## SMARTCODE BUILDING/SITE PLAN APPLICATION (ARTICLE 5)

### 2. Description of Project: 71-unit apartment building with underground parking

We have reviewed city staff comments. Please see our responses in red below and contact Jim Beltran with any questions.

PROJECT TITLE  
THE ADDISON  
BUILDING 2

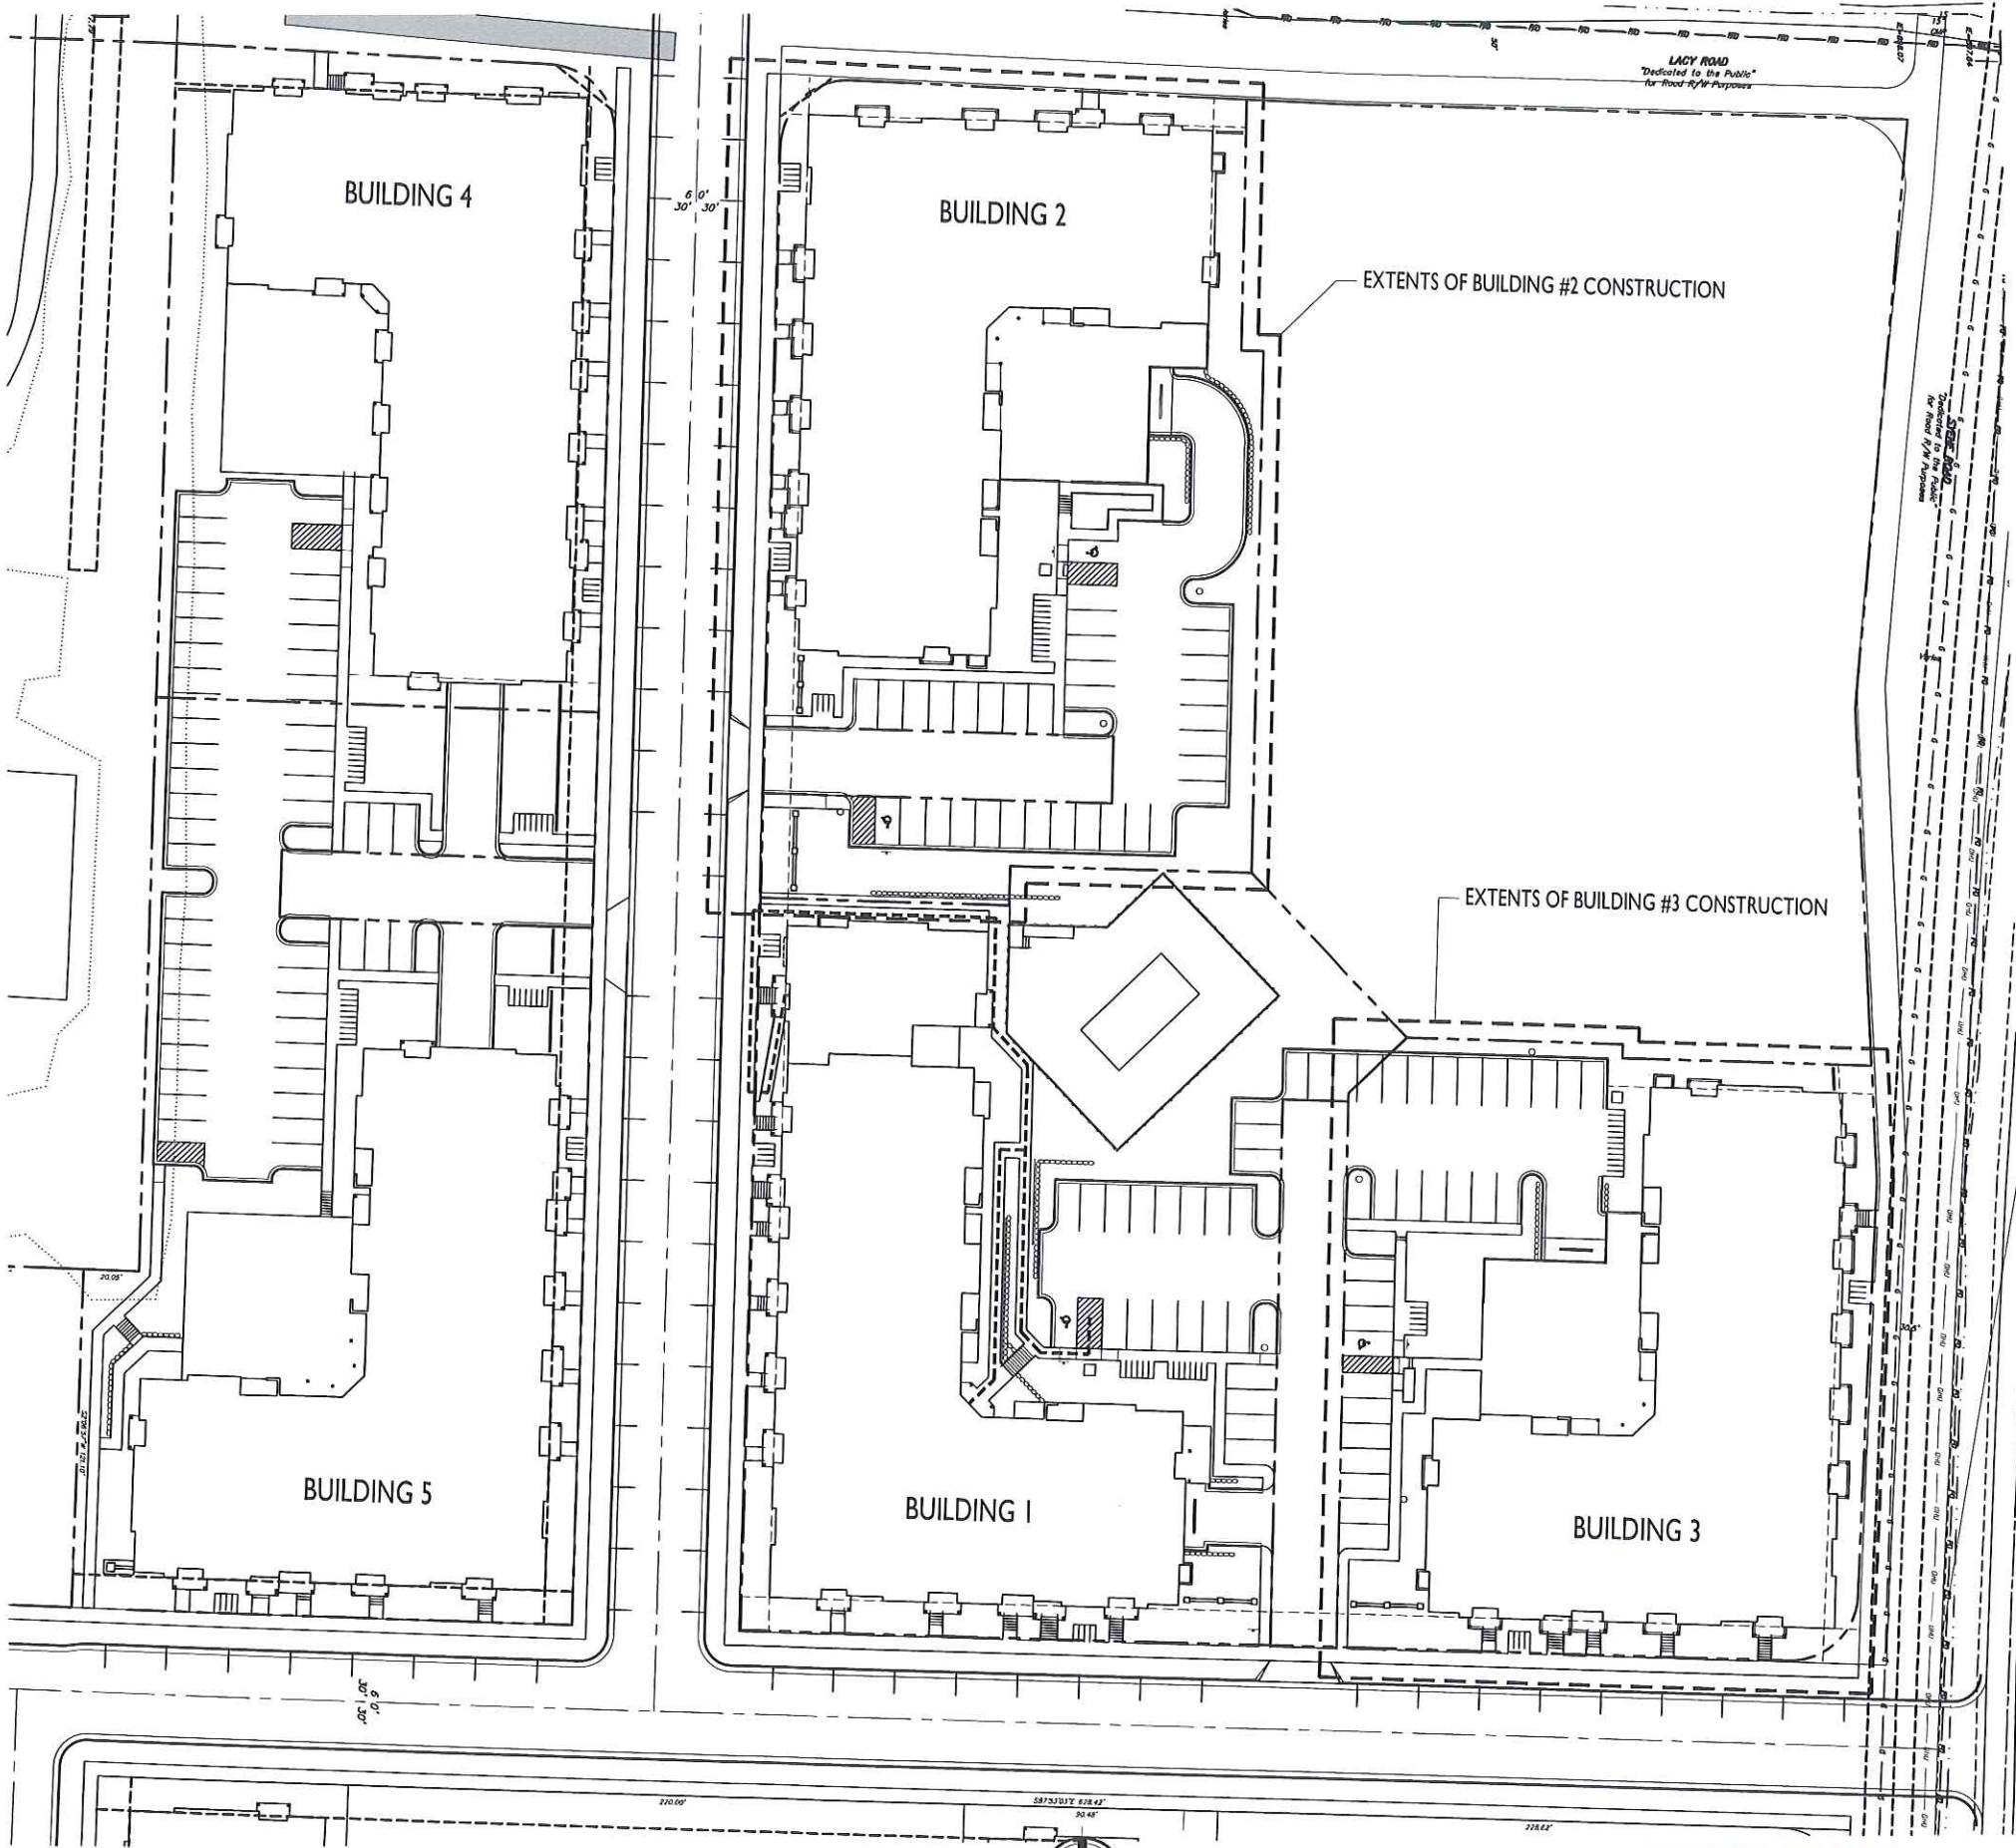
4. Please confirm the elevations of the parking lot over the existing storm sewer between North Park Lane and the stormwater pond on Outlot 6. This is an anticipated overflow route for events larger than the 100 year design storm and it's critical to ensure these extreme events don't flood out adjacent structures. **Vierbicher has reviewed these elevations and modified where necessary. See revised plan.**

1  
C-1.0  
OVERALL SITE PLAN  
SCALE: 1:30

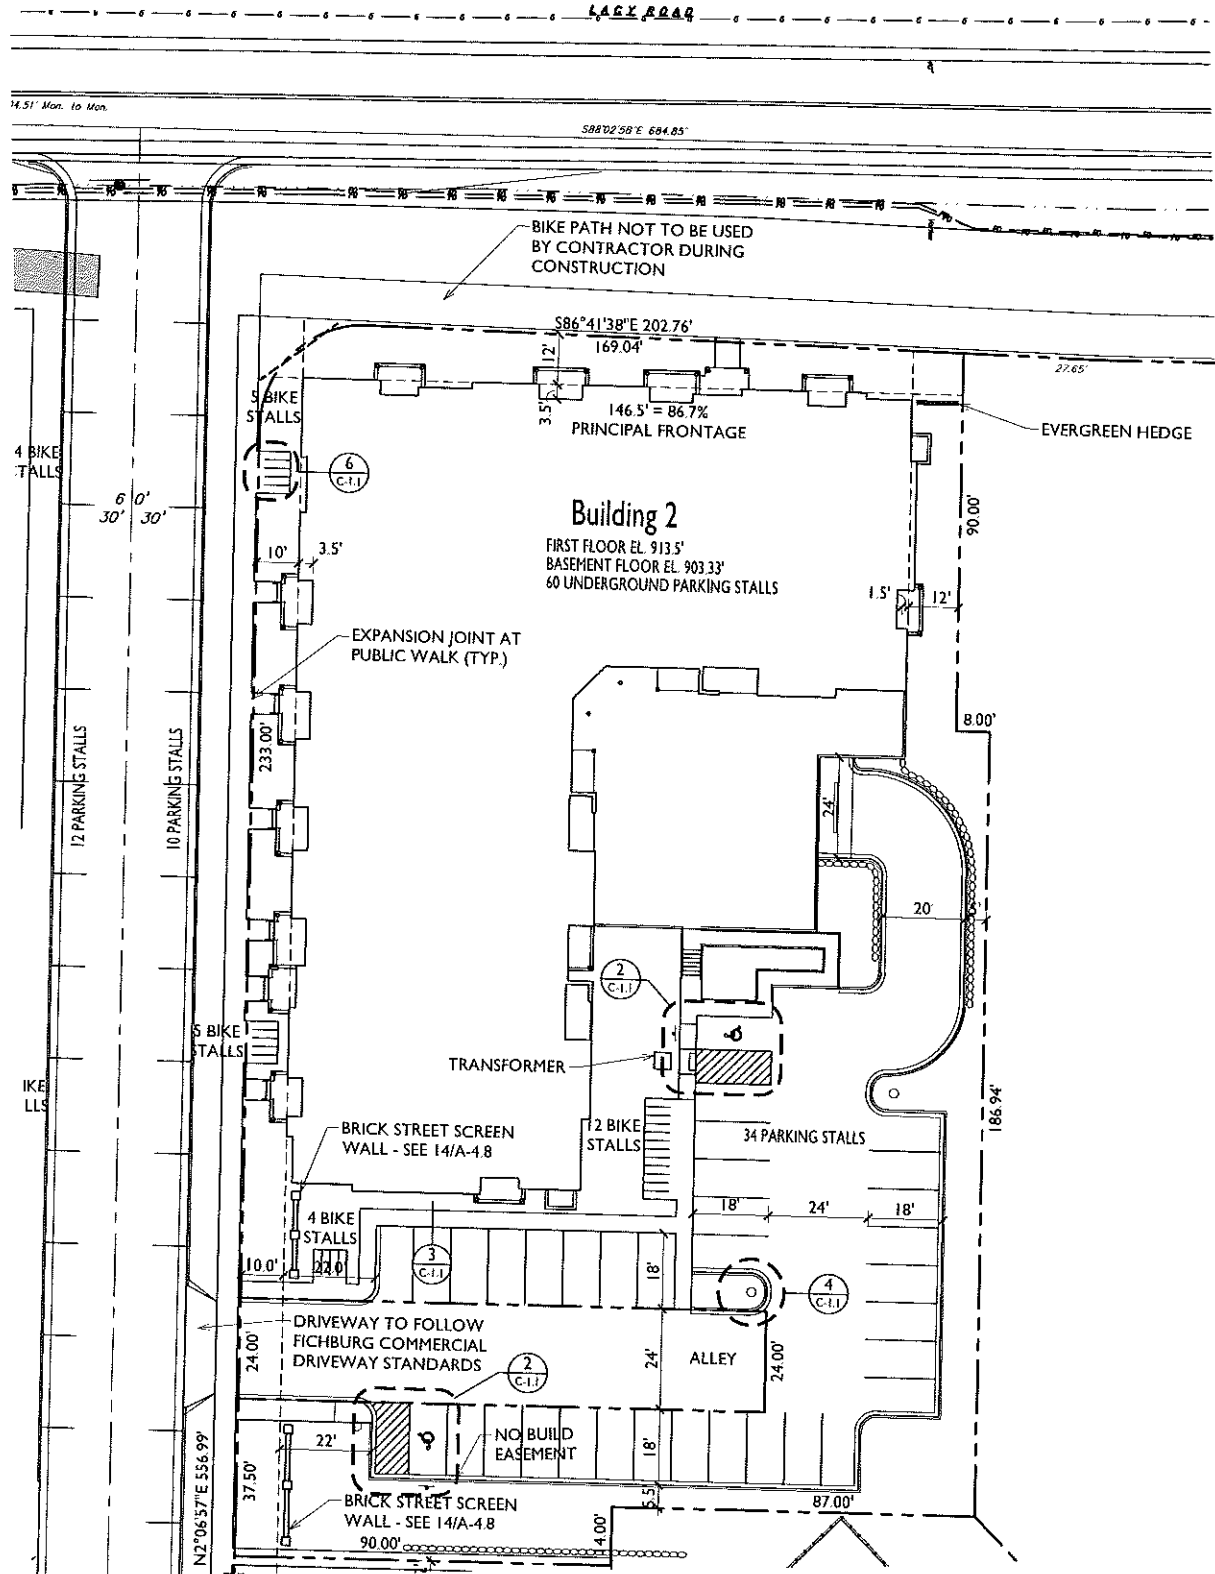
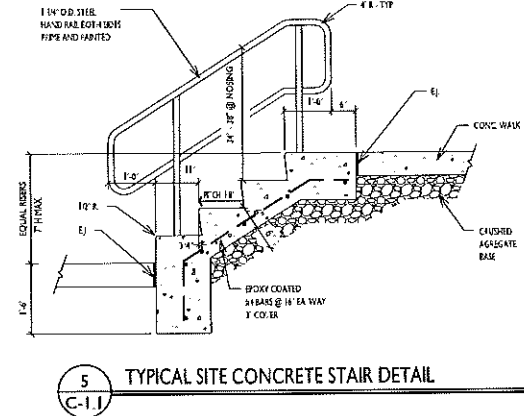
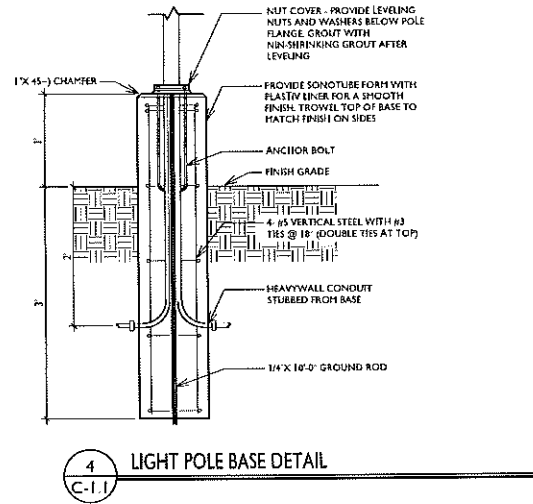
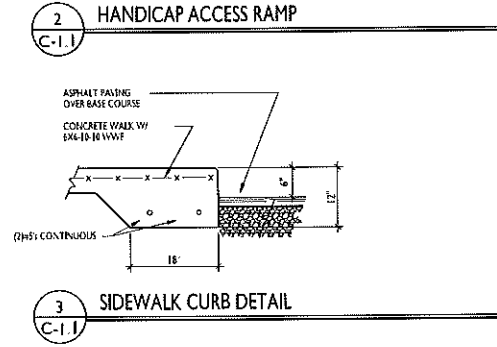
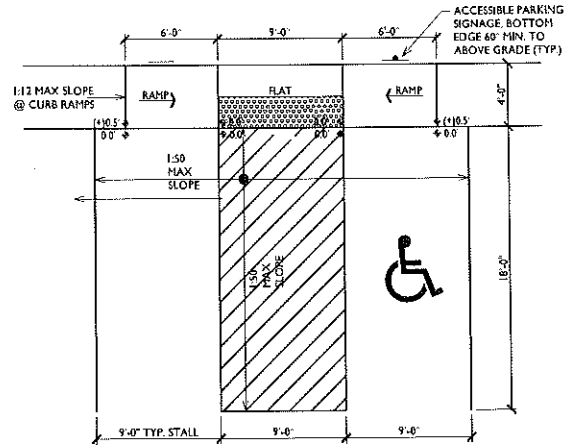
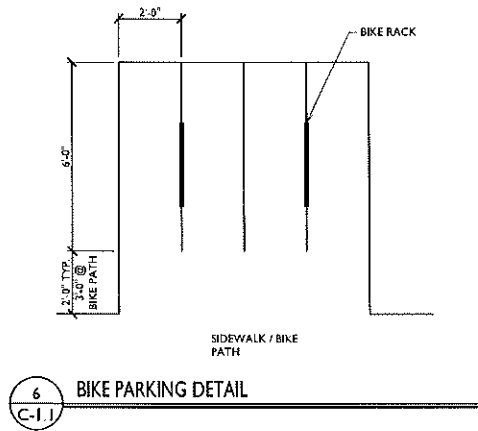
- 3.) Please better distinguish the property line on plan sheet C-1.1 as it's a bit hard to identify. **Line weight has been adjusted.**
- 4.) An Administrative Approval is needed for:

- 9.) Parking: Plan sheet C-1.1 notes that there are 60 underground stalls but the engineering drawings and landscaping plan note 59. Please be consistent. **This has been corrected.**

Similarly, sheet C-1.1 notes that there are 33 surface parking stalls, but I count 34 (including handicap). You should also be aware that only ½ of the available parking along the parking land corresponding to the lot Frontage for residential use counts toward the parking. Given this, you can count 5 street parking stalls to your parking totals. **Parking counts have been revised.**

3 HIDDEN ELEVATION  
A-2.2 SCALE: 1/8"=1'-0"

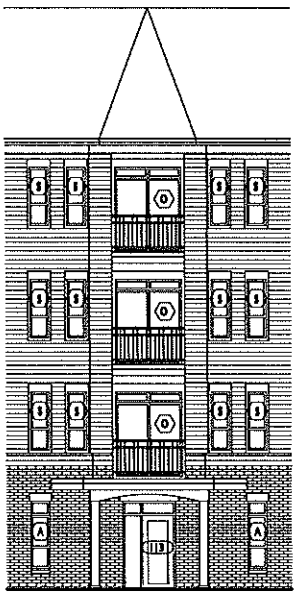
- 7.) I believe that the labels for the elevations on plan sheet A-2.2 are incorrect. It appears that the elevation labeled "West elevation" is in face the south elevation and the elevation labeled "South elevation" is the east elevation. Please update plan sheets appropriately to reflect the correct elevation. **Labels have been corrected.**
